# **Planning Commission**

Wednesday, January 7, 2026

# TECHNICAL REVIEW PLAT REQUIREMENTS REGULAR PLANNING COMMISSION MEETING January 7, 2026

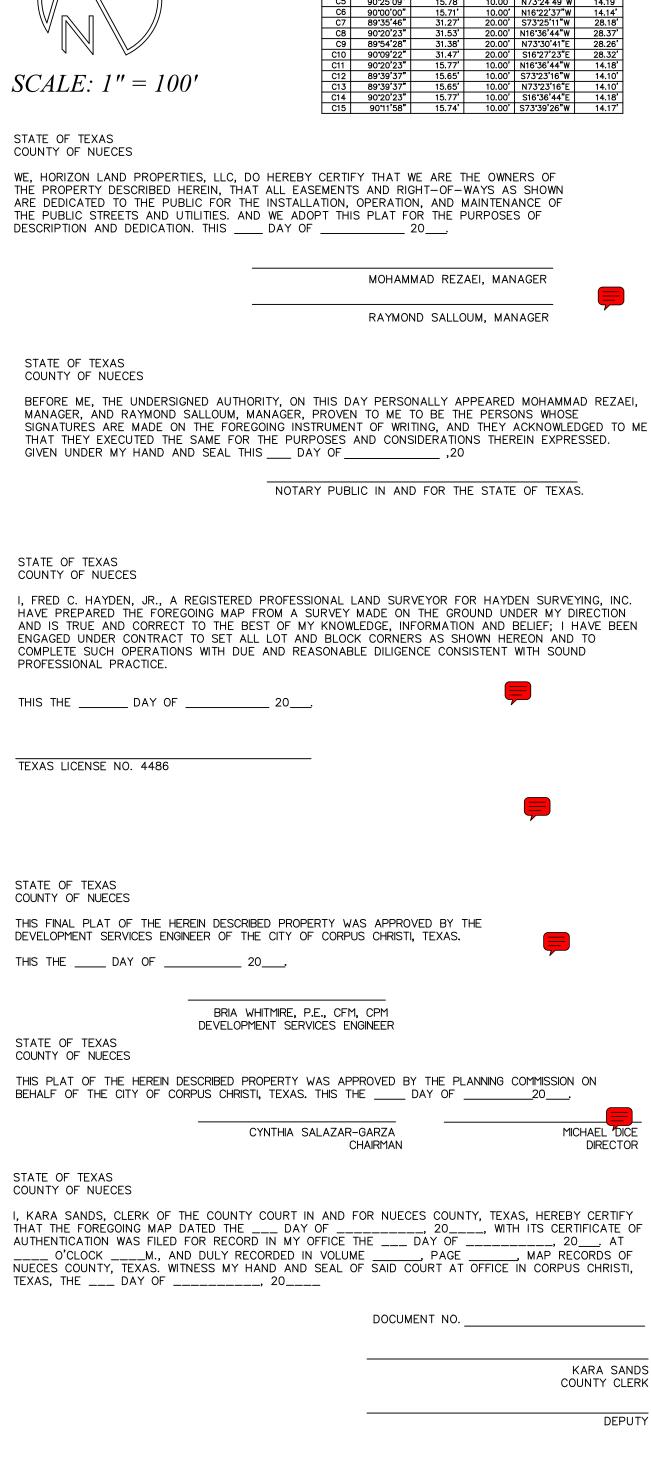
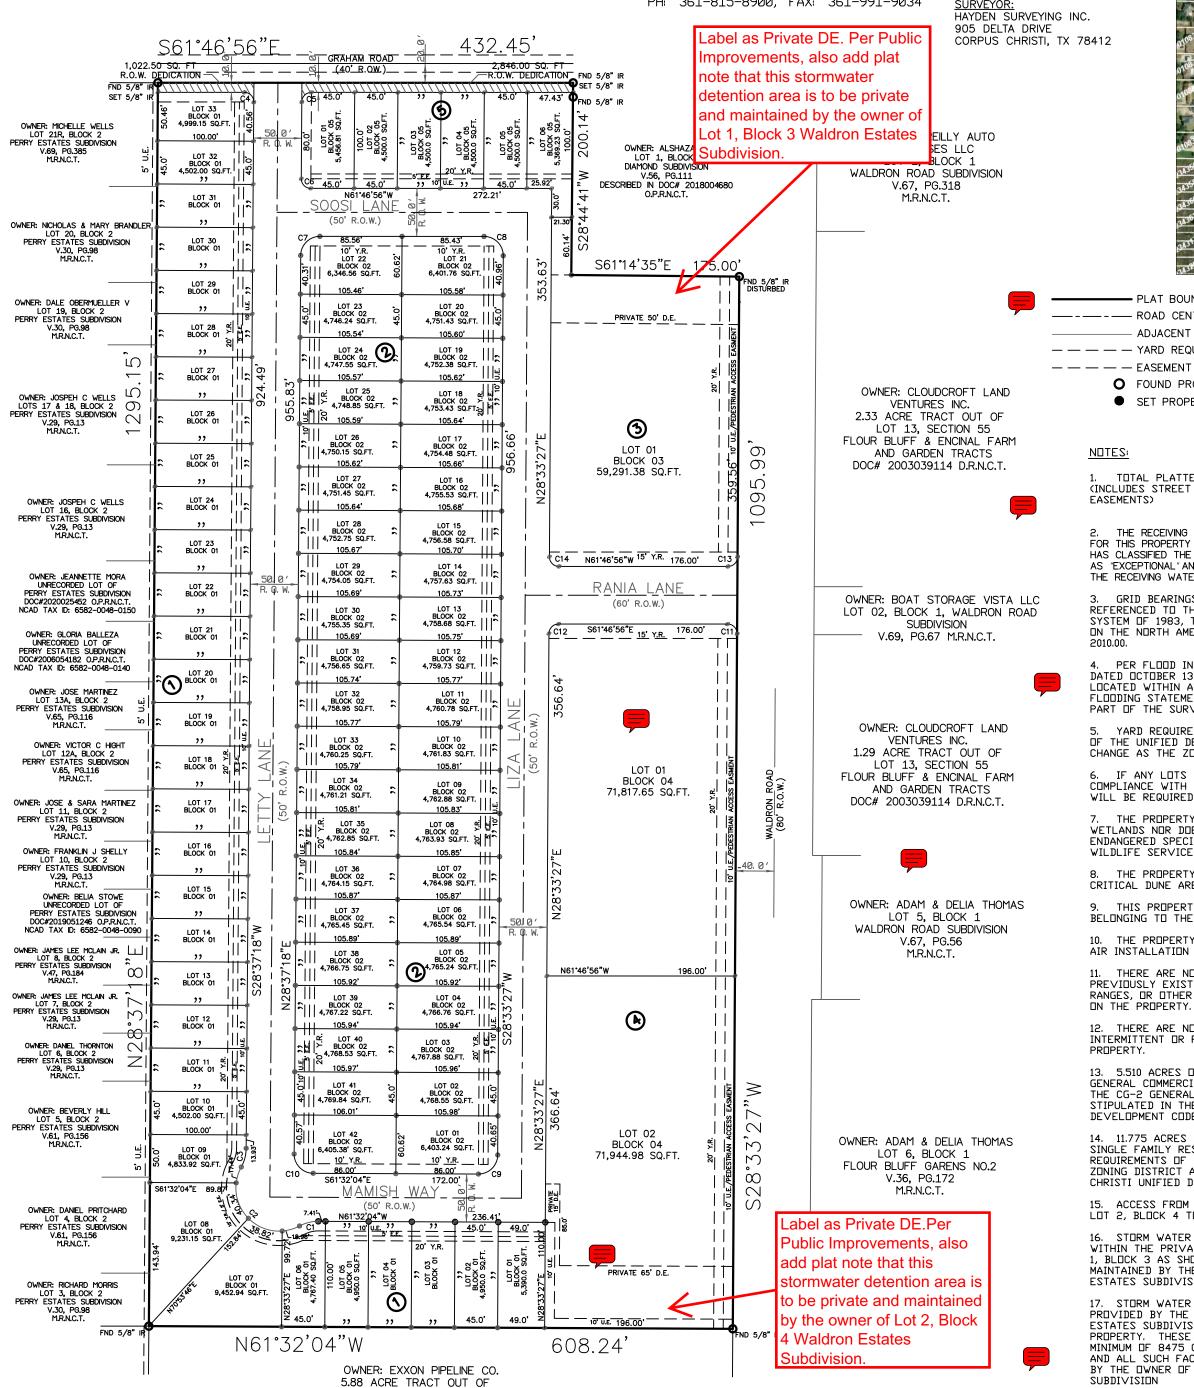
Comment ID	Author : Department	Status	Review Comments	Applicant Response Comments
12	Alex Harmon : DS	Closed	Improvements Required for Recordation, per UDC 8.1.4. A. Streets: Yes Sidewalks: Yes B. Water: Yes Fire hydrants: Yes C. Wastewater: Yes D. Stormwater: Yes E. Public open space: No F. Permanent monument markers: No Please note, improvements required should be constructed to city standards, found in Article 8 and the IDM.

Comment ID	Page Reference	Annotation Type	Author : Department	Status	Review Comments	Applicant Response Comments
9	P001	Callout	Alex Harmon : DS	Closed	Label as Private DE. Per Public Improvements, also add plat note that this stormwater detention area is to be private and maintained by the owner of Lot 1, Block 3 Waldron Estates Subdivision.	
10	P001	Note	Alex Harmon : DS	Closed	Per Public Improvement Plans, place plat note that future storm water detention capacity of 8,475 cubic feet to be provided as part of development of Lot 1, Block 4, Waldron Estates Subdivision. these storm water detention facilities shall be maintained by the owner of Lot 1, Block 4, Waldron Estates Subdivision.	
11	P001	Callout	Alex Harmon : DS	Closed	Label as Private DE.Per Public Improvements, also add plat note that this stormwater detention area is to be private and maintained by the owner of Lot 2, Block 4 Waldron Estates Subdivision.

2	P001	Note	Mark Zans : LD	Closed	Gas company request 10' U/E on Lot 2 Blk. 4 along south property line and 10' U/E along west property line of Lot 2 Blk. 4 for the length of Lot 01 block 01	
4	P001	Note	Mark Zans : LD	Closed	Add to notes as #15 Access from Block 3 Lot 1, Block 4 Lot 1 and Block 4 Lot 2 to Liza Ln. is prohibited.	
5	P001	Note	Mark Zans : LD	Closed	Change Michael Dice title to Director.	
6	P001	Note	Mark Zans : LD	Closed	Fire comments #1  1

Comment ID	Page Reference	Annotation Type	Author : Department	Status	Review Comments	Applicant Response Comments
					building on the premises at distances not exceeding 300 feet.  7□Plat□507.5.4 Obstruction. Unobstructed access to fire hydrants shall be maintained at all times. The fire department shall not be deterred or hindered from gaining immediate access to fire protection equipment or fire hydrants. Note: Hose lay from a hydrant will not cross an arterial street. 8□Plat□ 912.2.3 (amendment) Proximity to Hydrant: Fire department connections (FDC) for each sprinkler system or standpipe system shall be located not more than 100 feet from the nearest fire hydrant connected to an approved water supply.  9□Plat□503.1.1 (amendment) Buildings and facilities: Approved fire apparatus access roads shall be provided for every facility, building, or portion of a building hereafter constructed or moved into or within the jurisdiction. The fire apparatus access road shall allow access to three (3) sides of buildings in excess of fifteen thousand (15,000) square feet and all sides for buildings in excess of thirty thousand (30,000) square feet. 10□Plat□ 503.1.1 (amendment): During construction, when combustibles are brought on to the site in such quantities as deemed hazardous by the fire official, access roads and a suitable temporary supply of water acceptable the fire department shall be provided and maintained.

Comment ID	Page Reference	Annotation Type	Author : Department	Status	Review Comments	Applicant Response Comments
					unobstructed vertical clearance of not less than 13 feet 6 inches.  14□plat□D103.1 Access road width with a hydrant. Where a fire hydrant is located on a fire apparatus access road, the minimum road width shall be 26 feet, exclusive of shoulders.  15□Infor. □"A.□Where Fire Apparatus Access is constructed to the minimum of 20 feet, no parking is allowed within the fire apparatus lane.  B□Where a fire hydrant is located on the street, the minimum unobstructed clearance shall be 26 feet. In this instance, no parking is allowed on one side of the street.  C.□The minimum UDC residential street width is 28 ft. curb to curb. Any parking along the street that reduces the width to less than 20 ft. is prohibited and the Fire Code Official and will require painting "NO PARKING-FIRE LANE" along one side of the street"  16□Infor. □"Note: Calculated Turning Radii for Fire Apparatus: Inside Turn: 20 ft. 3 in.  Curb to curb: 36 ft. 8 in.  Wall to wall: 44 ft. 8 in."  17□Plat□503.4 Obstruction of fire apparatus access roads. Fire apparatus access roads shall not be obstructed in any manner, including the parking of vehicles. The minimum widths and clearances established in sections D103 shall always be maintained.  18□Plat□503.3 Marking: Where required by the fire code official, approved signs, or other approved notices the include the words NO PARKING-FIRE LANE shall be provided for fire apparatus access roads to identify such roads to prohibit the obstruction thereof. The designation of a fire lane can be marked with conspicuous signs which have the words:" Fire Lane-No Parking" at 50-foot intervals. In lieu of signs, fire lanes may be marked along curbing with the wording, "Fire Lane-No Parking" at 15-foot intervals.

Comment ID	Page Reference	Annotation Type	Author : Department	Status	Review Comments	Applicant Response Comments
					above requirements. The temporary turn-around may be removed upon completion of the street. 21 Note Comments are not to be considered all-inclusive. Development of the property will require further Development Services review.	
13	P001	Note	Mark Zans : LD	Closed	Water Department comments:  •□Water construction is required for platting (UDC 1.2.1.D & 8.2.6; Water Distribution Standards).  •□Approved A thorough review and comments of the proposed water and wastewater plan & profile to be address during Public Improvements Phase.	
14	P001	Note	Mark Zans : LD	Closed	Sewer Department:  • Wastewater construction is required for platting (UDC 1.2.1.D & 8.2.7; Wastewater Collection System Standards).  A thorough review and comments of the proposed water and wastewater plan & profile to be address during Public Improvements Phase.

15	P001	Note	Mark Zans : LD	Closed	•□Approved  Park Development fee:	
16	P001	Note	Mark Zans : LD	Closed	81 Units x 462.50 = \$37,462.50  Is there going to be a HOA for this development? Who will be maintaining the private drainage easements?	
17	P001	Note	Mark Zans : LD	Closed	Traffic comments:  □The proposed plat does not impact or alter the existing Roadway Master Plan.  □Proposed Driveway access to public City Street shall conform to access management standards outlined in Article 7 of the UDC (UDC 7.1.7)  □Proposed ROW to reflect as the street(s) design and their pertaining categories/ type as per Article 8 of the UDC (UDC 8.2.1)  □The PW-Traffic Department (Right-of-Way Division) is responsible for reviewing and permitting new construction and repairs/modifications to driveways, sidewalks, curb, and gutter, and utility easements. The review and approval of the permit must be approved prior to the issuance of the building permit (issued by DSD). (Refer to Municode Chapter 49-30 for permit requirements.)  □A ROW Construction Permit, issued by PW-Traffic Department (Right-of-Way Division), is required for any work obstructing, closing, or occupying public right-of-way (Reference Chapter 49-2). Work within
